PRODUCT / PROCESS CHANGE NOTIFICATION

1.1 Company	 STMicroelectronics International N.V
1.2 PCN No.	MDG/24/14486
1.3 Title of PCN	STM32U575x & STM32U585x - product Enhancement
1.4 Product Category	STM32U575x STM32U585x
1.5 Issue date	2024-07-10

STM32U575x and STM32U585x - product enhancement

Example: Marking on package UFBGA 7X7X0.6 132L

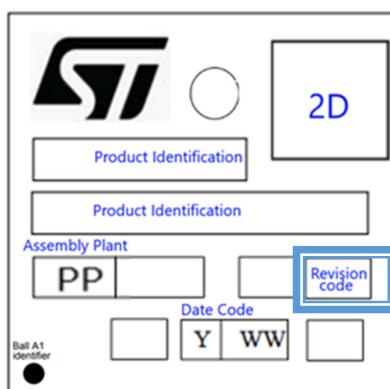
STM32U575xx and STM32U585xx (Die482 - cut3.3 revision U) product enhancement fixes three limitations related to low-power modes as described in Errata Sheet (ES0499 - Rev 10 - July 2024):

- Device hang-up can occur when wakeup request received a few clock cycles before entering Stop 2 or Stop 3 mode.
- Device may be locked upon system reset under Stop 2 mode.
- Device may hang up when entering low-power modes.

STM32U575x STM32U585x	Current Die 482 Cut 3.1	New Die 482 Cut3.3
Die revision Marking R	“W”	“U”
